**REQUEST FOR
A PHYSICAL MAP REVISION
FOR CAMINO DE OESTE WASH**

RE: REQUEST FOR A PHYSICAL MAP REVISION

IN REPLY REFER TO:
Case No.: 99-09-434P

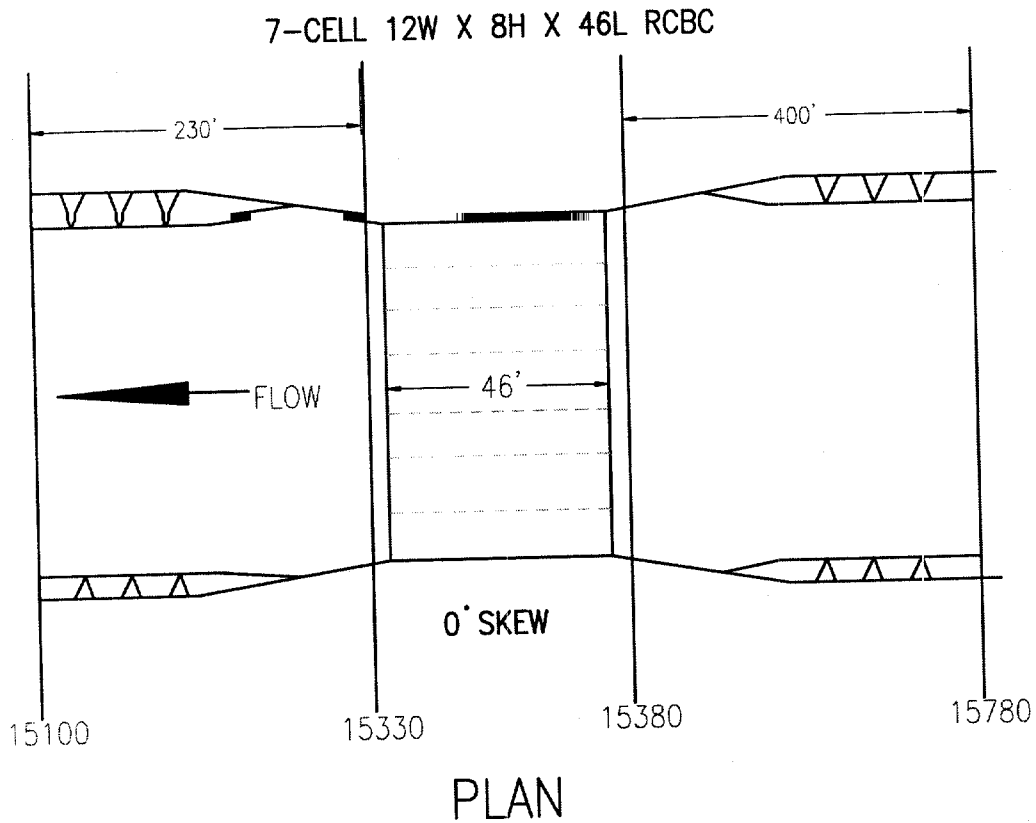
Speedway Boulevard culvert provided on FEMA Form 7, entitled "Bridge/Culvert Form," shows the invert elevation at the culvert centerline to be 2,599 feet. Please either revise the GR data for Sections 15380 and 15330 of the submitted HEC-2 model to agree with the culvert invert elevations in the SC record, or revise the data in the SC record and the culvert information on Form 7.

1. A revised HEC-2 hydraulic computer model in which the discrepancy between the data in the GR and SC records at Speedway Boulevard has been resolved. The data used in the GR and SC records must agree with the data on Application/Certification Form 7, entitled "Bridge/Culvert Form."

1. A revised HEC-2 hydraulic computer model is attached which resolves the discrepancy between the data in the "GR" and "SC" records for the existing culvert structure, located at Speedway Boulevard.
2. An erosion analysis was not performed along study reach of the Camino de Oeste Wash. However, the 100-year flow velocities along this reach are of a magnitude that would likely cause some degree of erosion of the earthen channel banks. Pima County drainage regulations require that conservative erosion-hazard setbacks be utilized along such channel reaches, unless a detailed erosion study is performed, or unless approved bank protection measures are constructed along the watercourse.
3. Revised topographic work maps and annotated copies of Flood Insurance Rate Maps are attached.
4. A computer disk containing input and output files for the submitted computer model is attached.

FIGURE 1

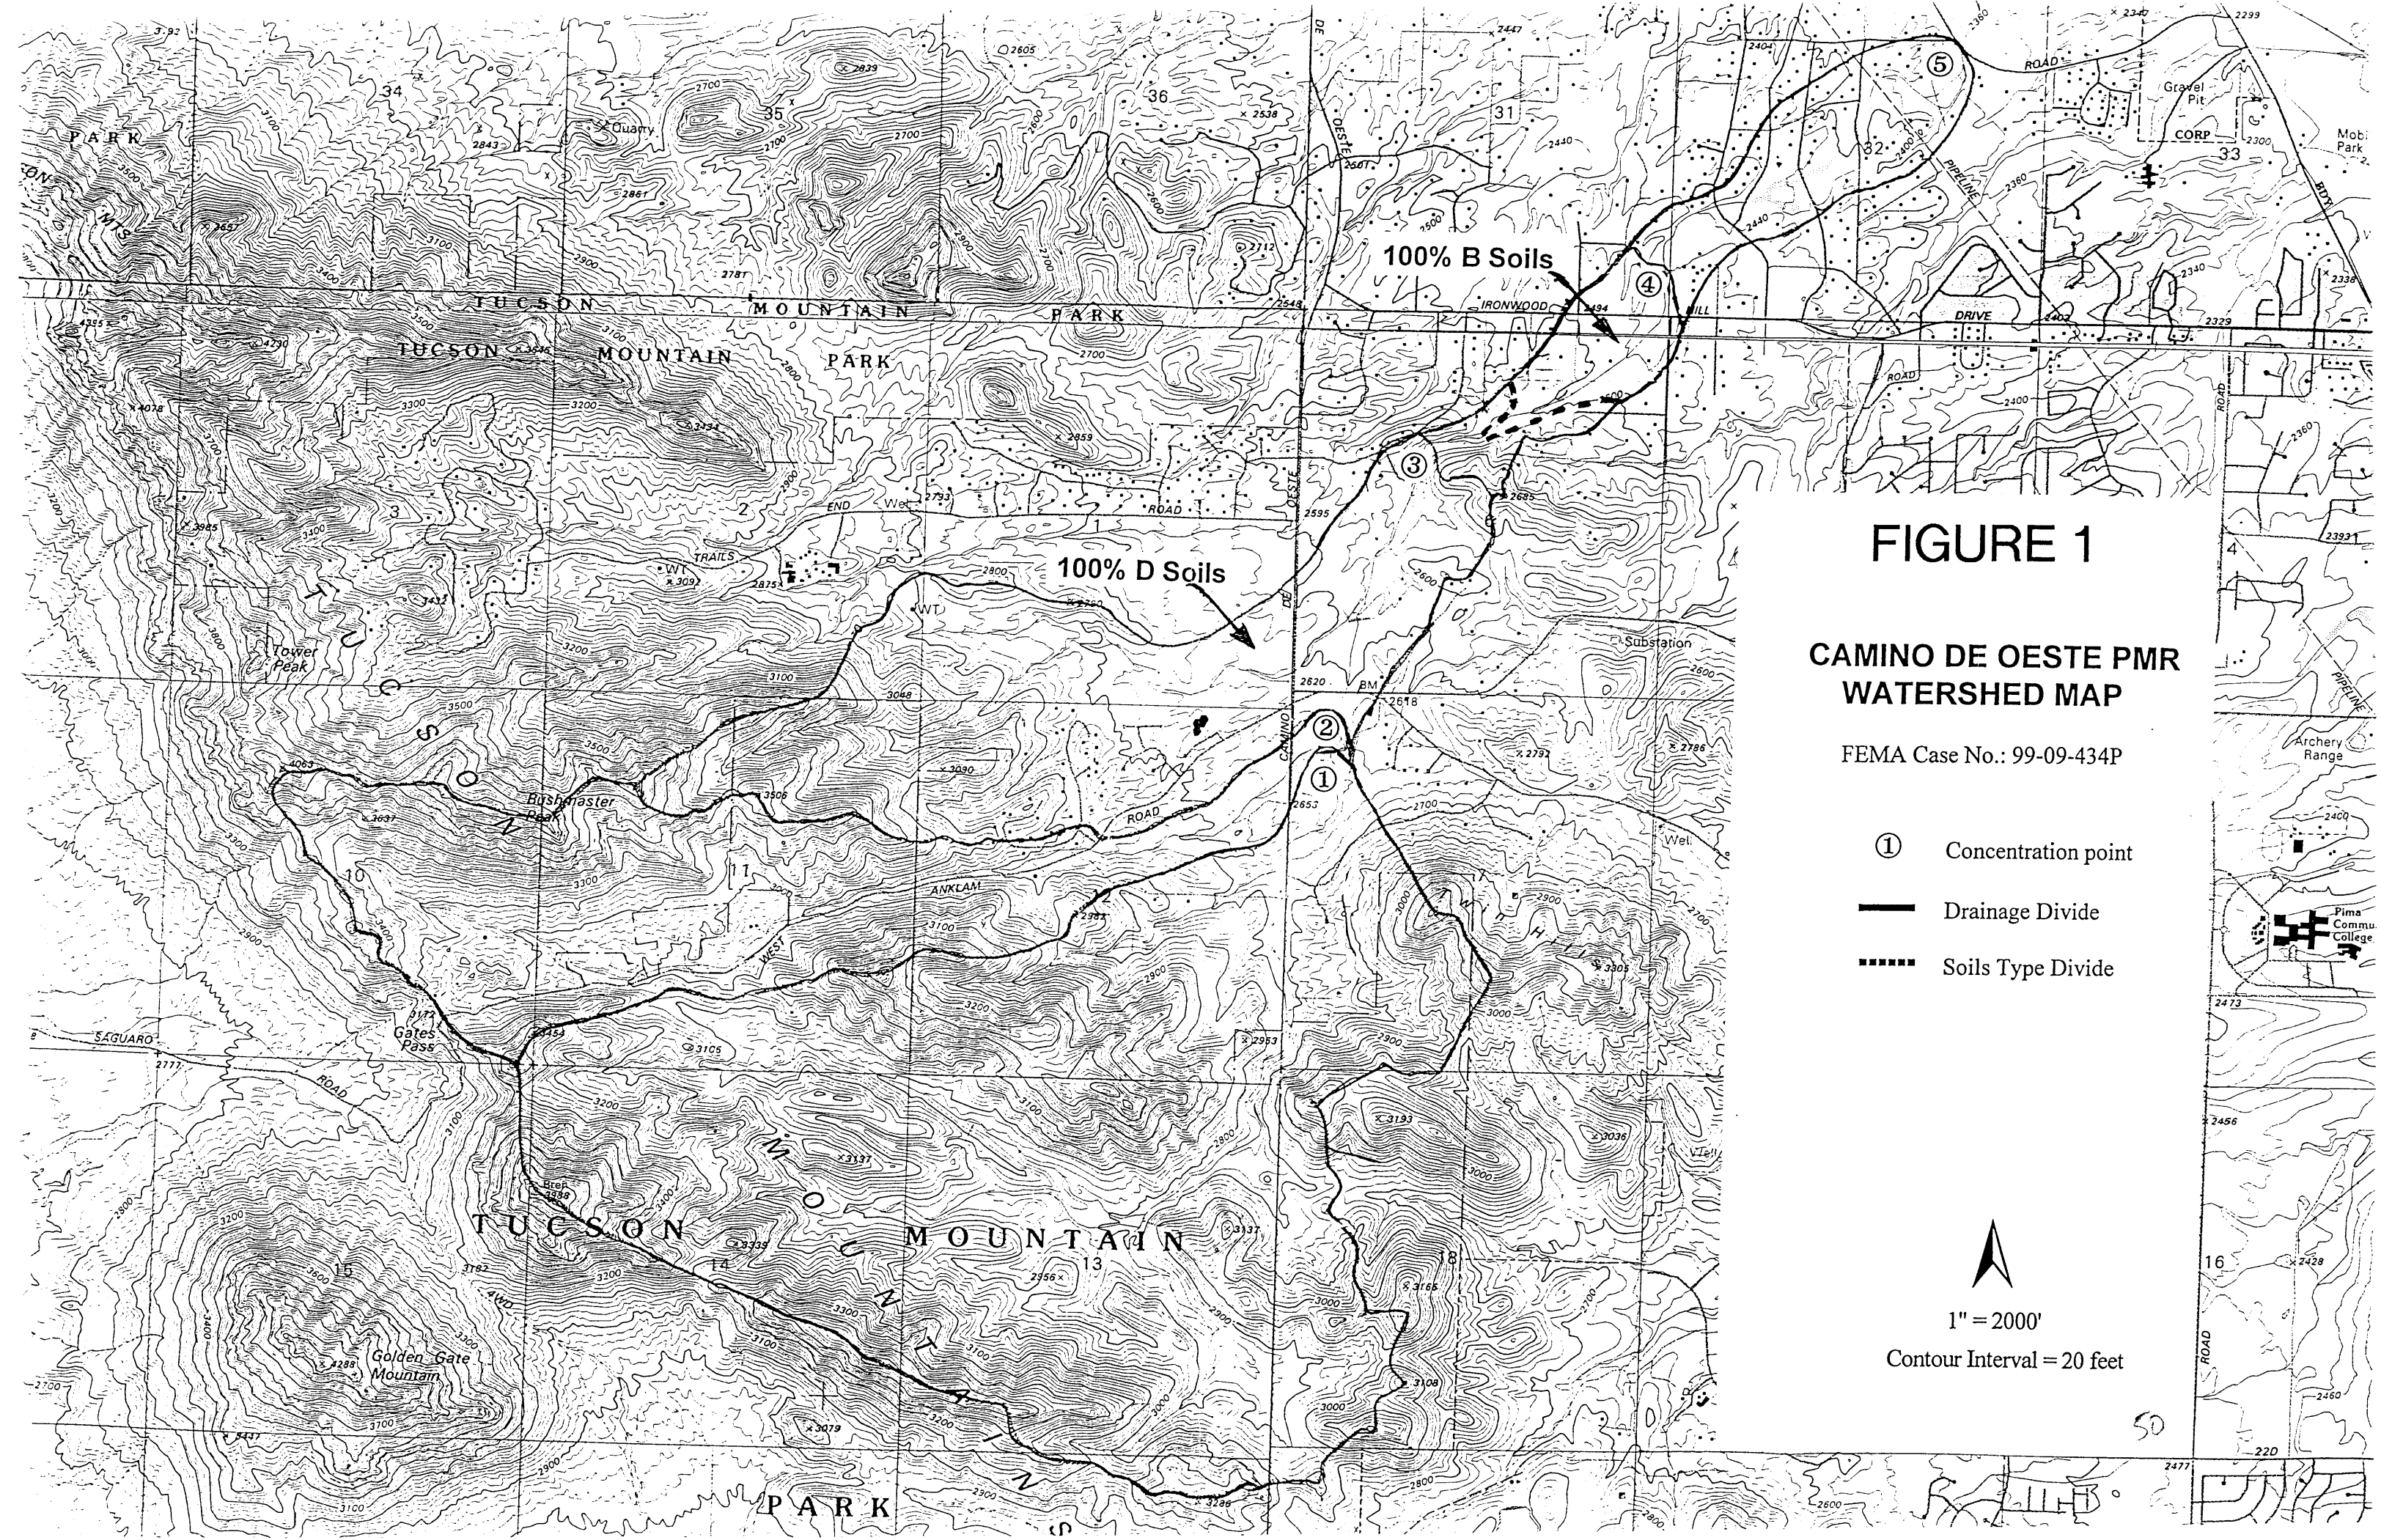
Please revise the base flood discharge values in the submitted hydraulic analysis using the regression equations in WRIR 84-412. Alternatively, please revise the discharge values based on the May 5 hydrologic analysis, and submit documentation to demonstrate why it is more appropriate to use those values.

Enclosed with this letter is a report containing revised hydrologic data, prepared in response to the review letter dated May 20, 1999, regarding the above referenced submittal. The reviewer expressed a concern about our use of the Pima County Hydrology Method (PC-HYDRO) for base flood determination, instead recommending the USGS regression equation WRIR 84-4142. We were offered the option of choosing PC-HYDRO under the stipulation that we document its appropriateness in this situation. The Procedures section of the report supports our decision to use the PC-HYDRO Method.

This report contains revised base flood peak discharge values, which are intended to replace those used in the Camino de Oeste Wash Physical Map Revision, submitted January 28, 1999. Further, this report addresses a concern with the method used to generate the peak flood discharges, as stated in Paragraph 1 of the review letter dated May 20, 1999.

Figure 1 shows the Camino de Oeste Wash basin boundaries delineated on USGS 7.5 minute quadrangles, (Cat Mountain (1992) and Jaynes (1992)), at 1:24000 scale. Also shown are five concentration points where new 100-year discharge values have been calculated.
